BORAL LAND AND PROPERTY GROUP

Response to Submissions
Stockton Sand Quarry Dredging Project
Volume 2

Figure 4: Distribution of GDEs and groundwater reliance

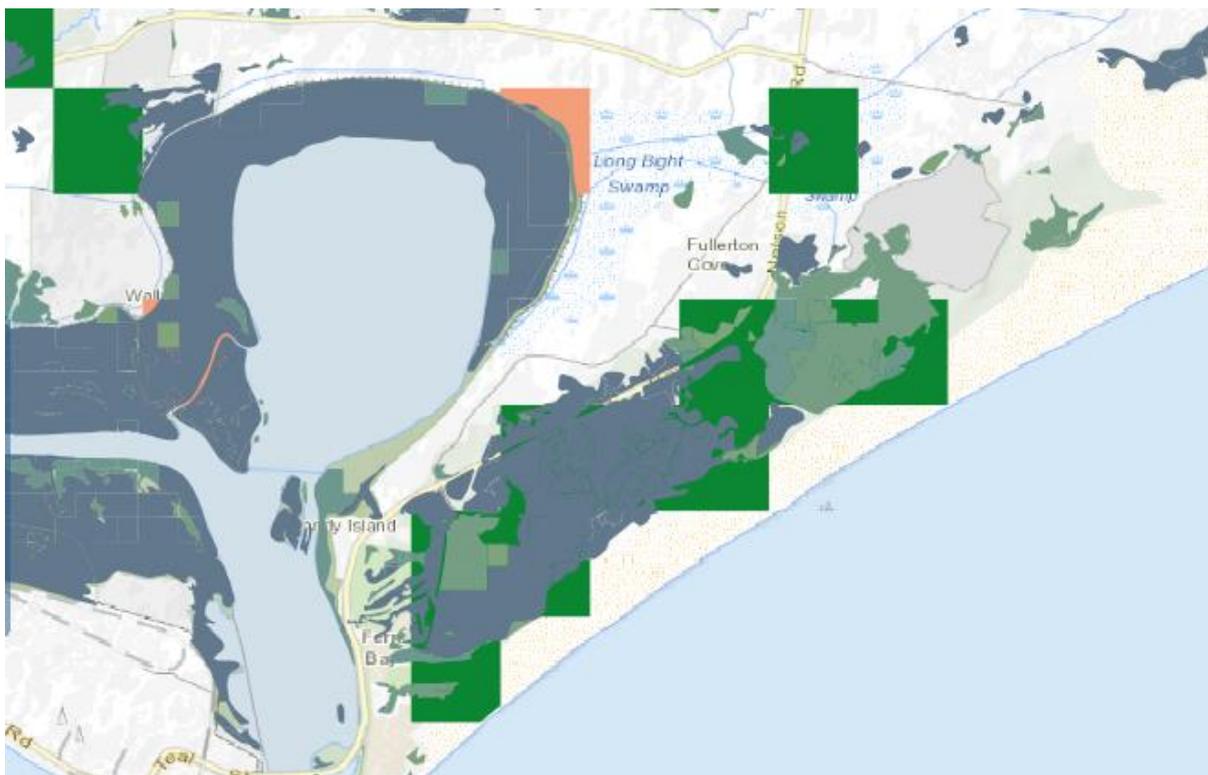
The identified terrestrial GDE, within the site and on land immediately surrounding, is “highly likely” to be reliant on groundwater including groundwater inflows as well as rainfall. The extent of this GDE is shown in **Figure 4**.

As the groundwater levels within the aquifer have been predicted to remain stable and close to current static conditions over the 25 year period of the project, it is unlikely that the identified GDEs would be impacted.

Figure 6: Identification of GDE's in relation to the project site (source: modelling report, EES; 2020)

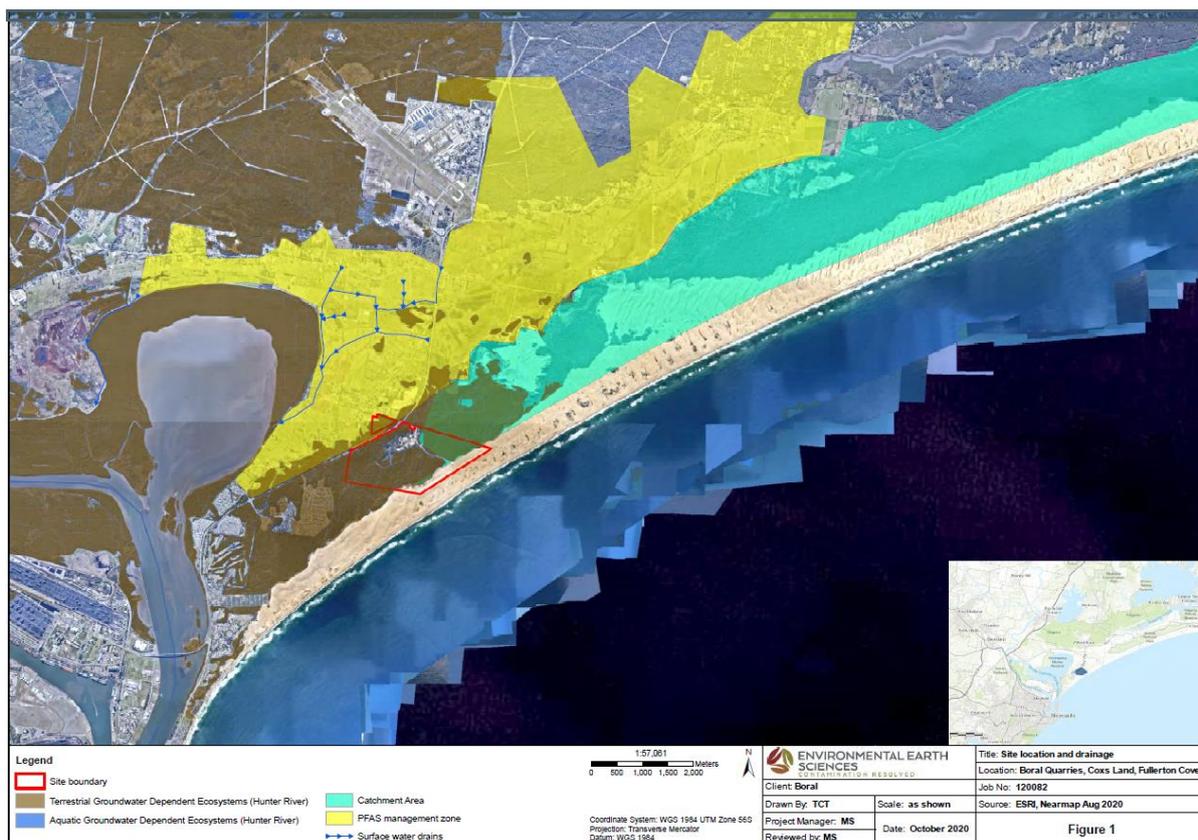
Figure 6 identifies the location GDEs relative to Boral’s site. The potential for these ecosystems to be impacted by the development was assessed as part of the aquifer model prepared by EES (**Appendix E**). The potential effect of the project on these GDEs is considered in detail in **Appendix F**.

Modelling of the aquifer prior to and post project approval indicates that water levels will remain relatively static within and around the site indicating that the potential for GDEs to adversely affected is low.

Figure 7: Distribution of “Sydney Freshwater Wetlands” GDE (source: East Coast Flora Survey, 2010)

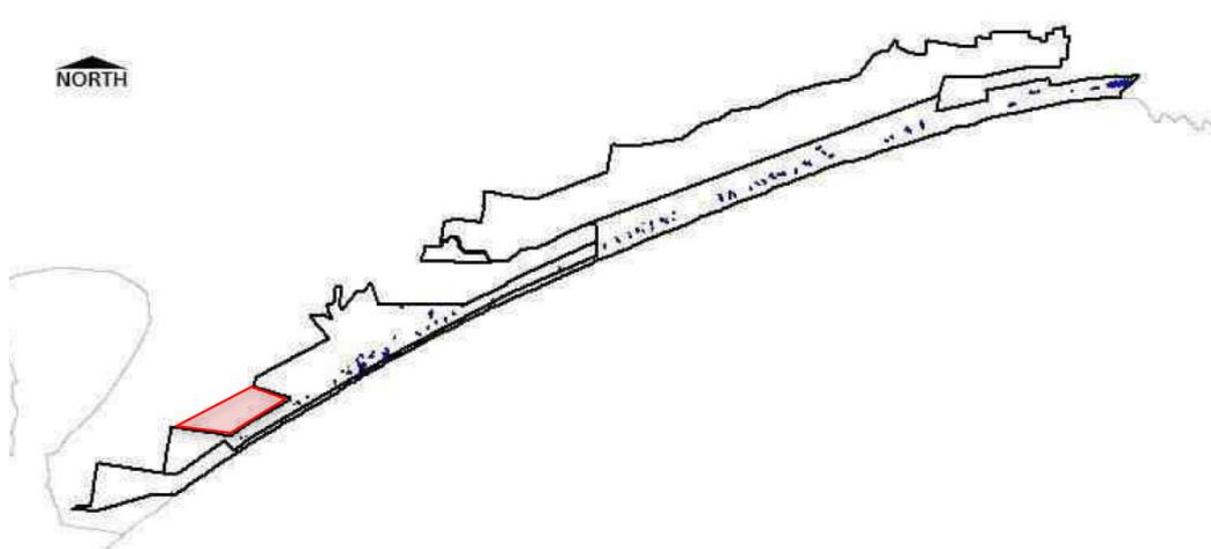
The location and distribution of the identified GDE is shown in **Figure 7** marked by small blue dots stretching along the dune system of Stockton Beach. Also identified below is the location of Boral's site relative to the identified GDE, identified by red outline.

The outcome of the model indicates that the groundwater levels are unlikely to be altered by the project. In this regard, it is considered unlikely that the project would impact on GDEs including those located southeast of the site on the frontal dune system.

Figure 1
Final landform

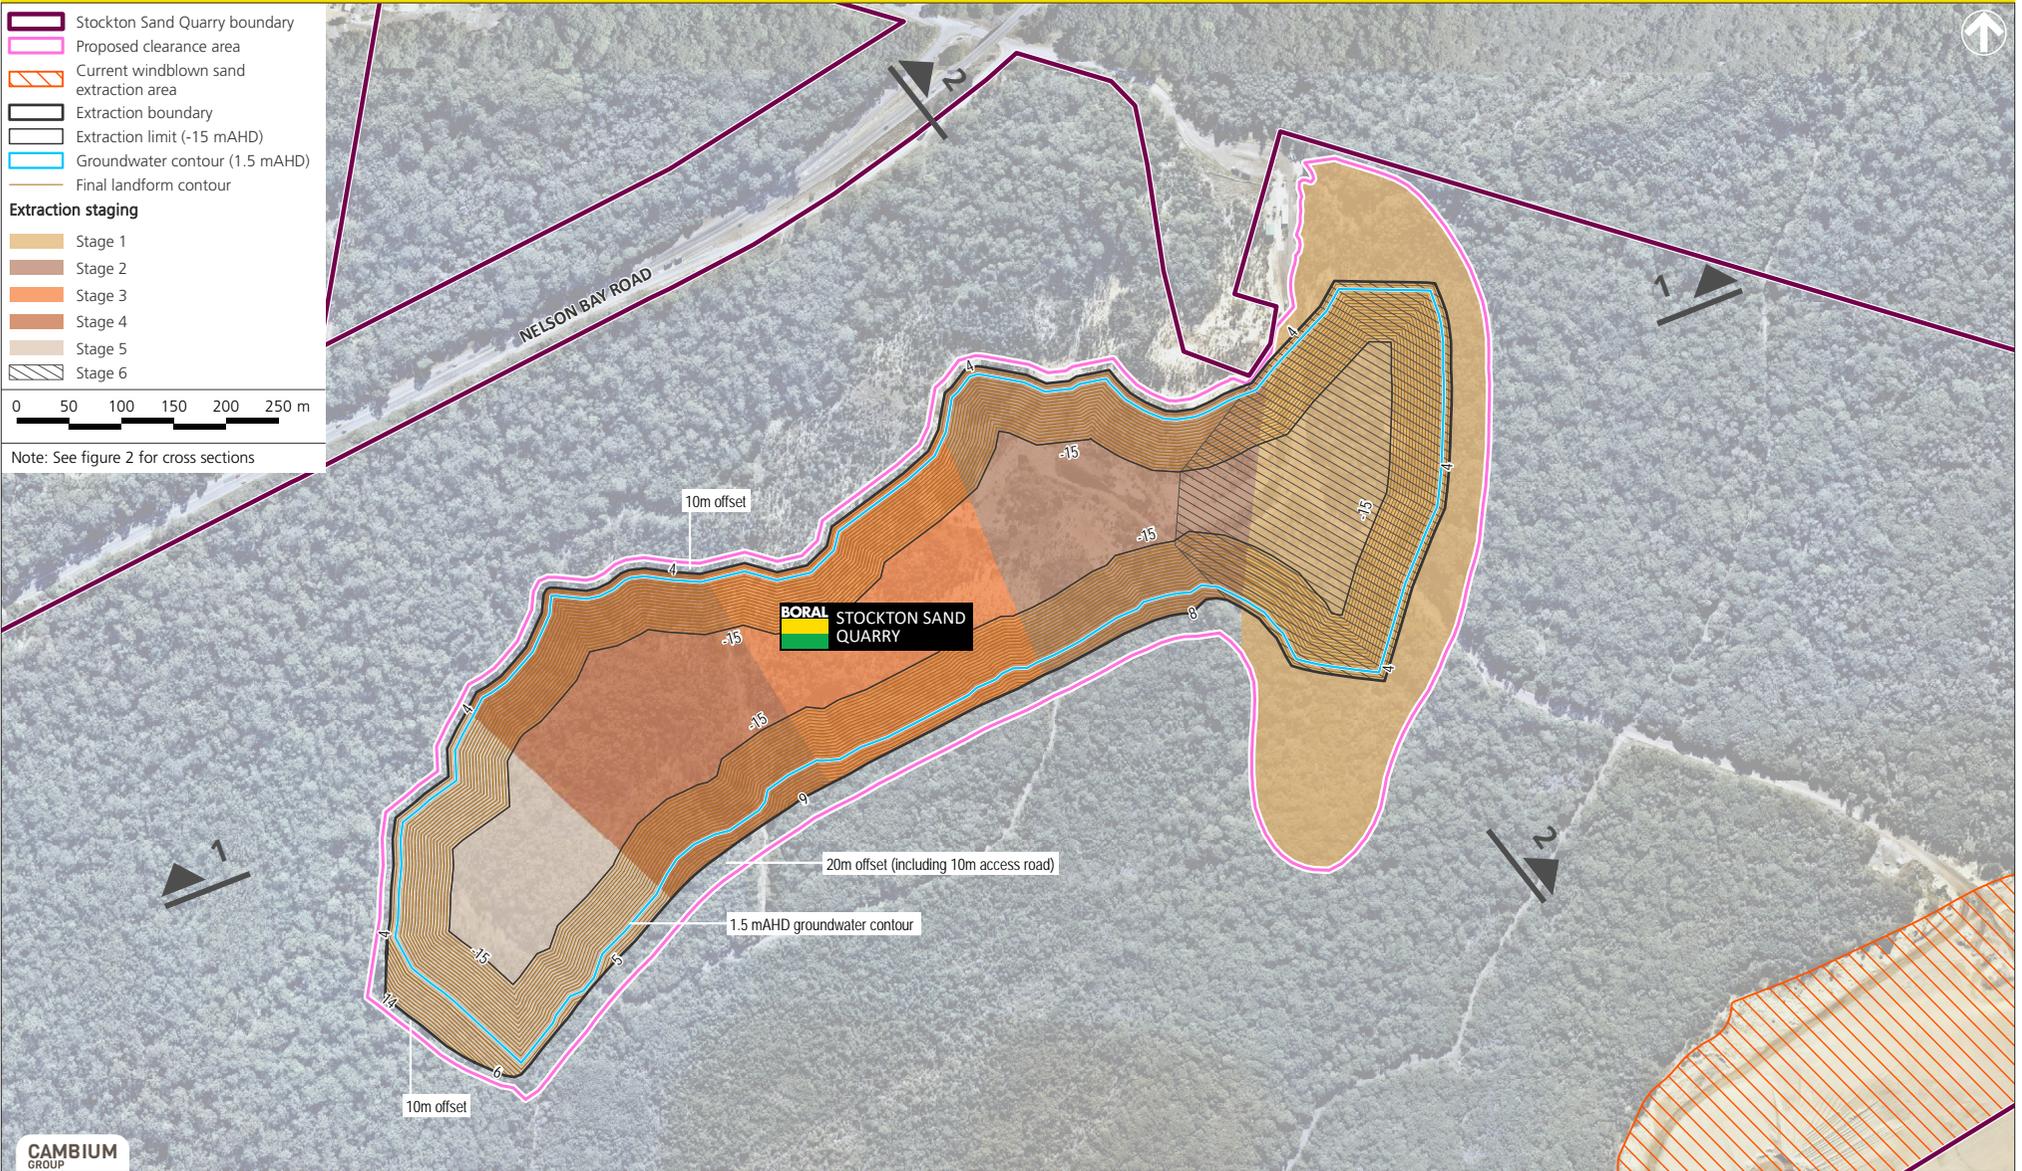
Stakeholder	Comment		Location in rehabilitation plan
DPIE – BCD	1	The proponent should develop a final landform map, showing the expected footprint of the dredge pond, including different depths within the pond (such as the limit of the -15 m AHD extraction).	Figures 3 to 5
	2a	The proposed strategy to rehabilitate the dredge pond to a freshwater wetland should be reconsidered.	N/A
	2b	If the proponent decides to pursue this strategy, it should detail how wetland conditions can be established in such a deep environment and any rehabilitation activities required to achieve this.	Section 4 – wetland conditions Sections 5 to 6 – rehabilitation activities
	2c	The proponent should also detail any long-term management measures that will be implemented to ensure the pond is not degraded by pests, degrading water quality or other issues.	Section 4, Section 5 and Section 6
	3	The proponent should develop rehabilitation success criteria and objectives that are relevant to the dredge pond. This should cover the establishment of appropriate biological functions in the pond and the long-term management of issues such as aquatic pests and water quality.	Section 6

- A final landform plan (**Appendix B**) has been prepared by Cambium, showing the gradient/batters within the dredge pond, confirming the existing/finished ground levels of land surrounding the final dredge pond and the extent of the pond that will reach depths of –RL15 metres;
